MEMORANDUM

RE: Recreation Storage and Irrigation POU Shape Update

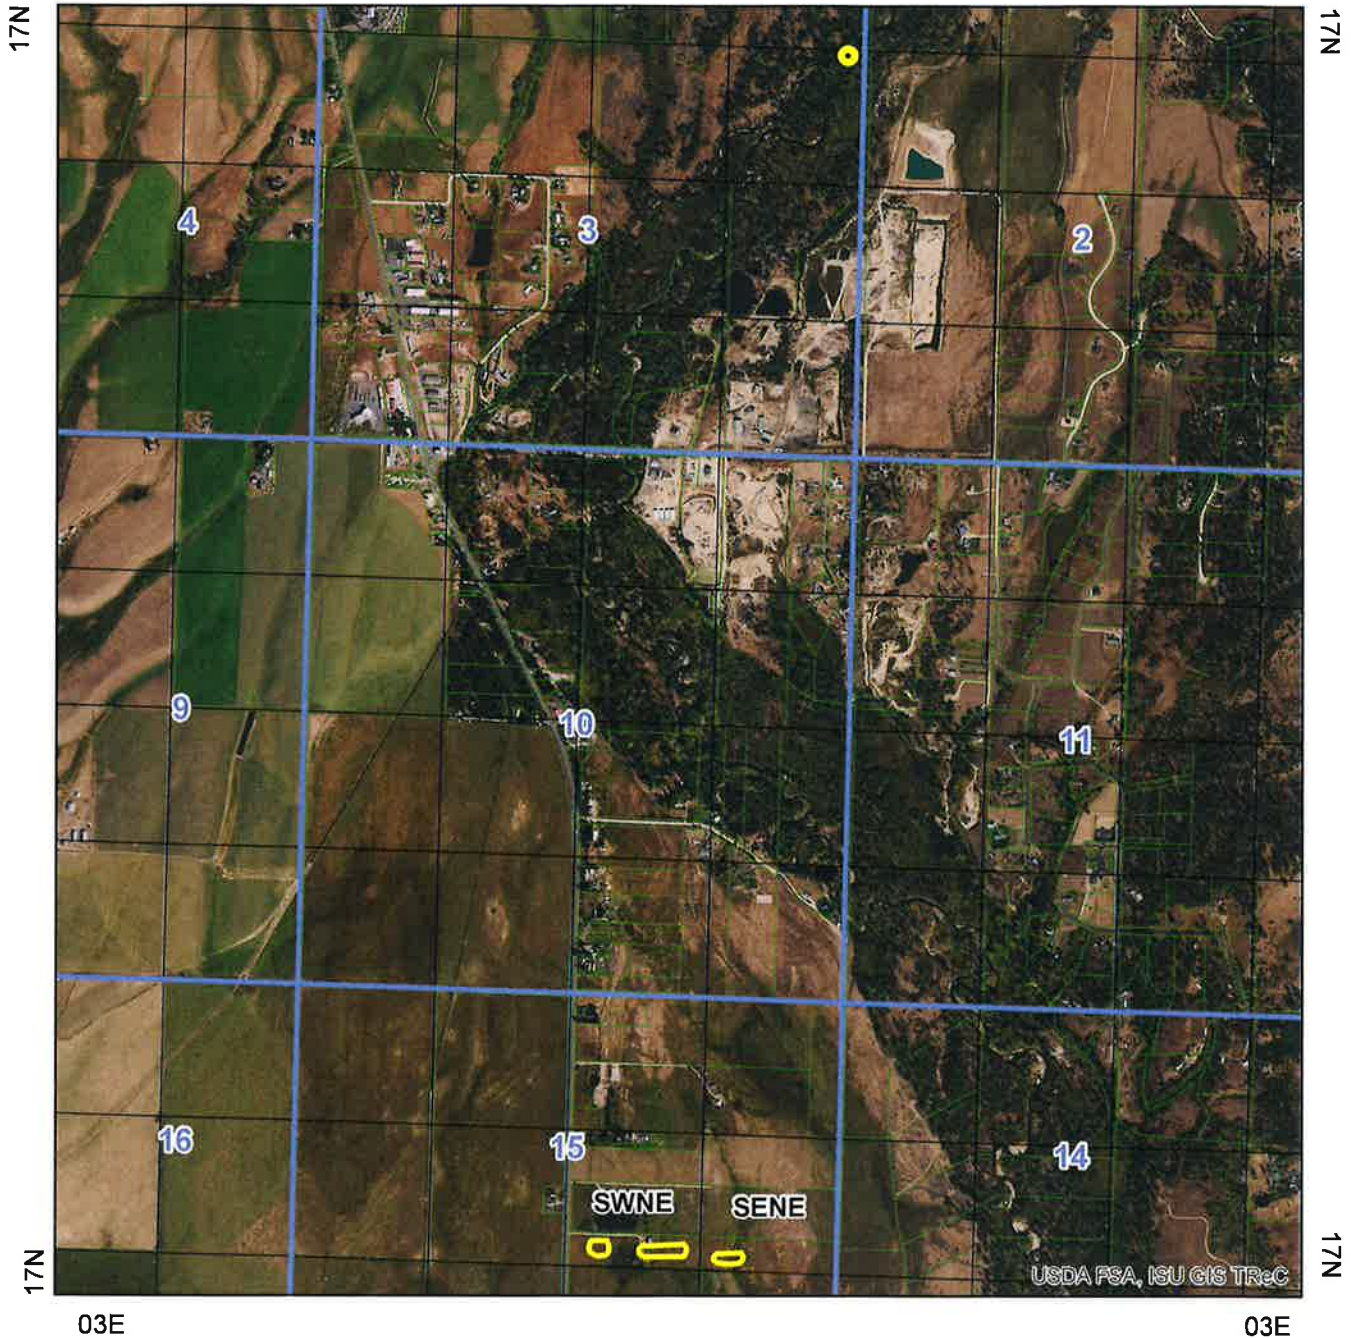
On July 31, 2018, Nick Miller (Manager IDWR Western Region) met with Dustin Fee during an office day visit. At that time, Dustin pointed out an apparent error in the place of use (POU) shapefiles right 65-3211B and permit 65-22928. I reviewed the backfile for both water right records. The following summarizes my understanding of the facts and findings:

- Dustin Fee is the landowner of parcel #RP17N03E152316 (as identified by 3/8/18 Valley County parcel information), which is the land upon which the current POU shapes for 65-3211B and 65-22928 reside. He is requesting we remove the shapes from his parcel and place them on the parcel to the north as that is the correct place of use per his knowledge and understanding (see attached 65-3211B Recreation Storage POU Shape as of 7/31/18, 65-3211B Irrigation POU Shape as of 7/31/18, and 65-22928 Recreation Storage POU Shape as of 7/31/18 showing POU shapes prior to this memo).

- Permit 65-22928 authorizes a recreation storage surface area of 10.5 acres. Recreation storage POU shapes for 65-3211B and 65-22928 are only ~2.3 acres currently.

- The requested change to POU shapefiles is within the same PLS currently authorized for the place of use. No transfer or permit amendment is required to update the shapefiles.

On August 9, 2018, I updated the Recreation Storage POU shapes for right 65-3211B and permit 65-22928. In addition, I updated irrigation POU shape for right 65-3211B. On August 10, 2018, the POD shapes for permit 65-22928 were also updated to depict centroids of the recreation storage ponds.
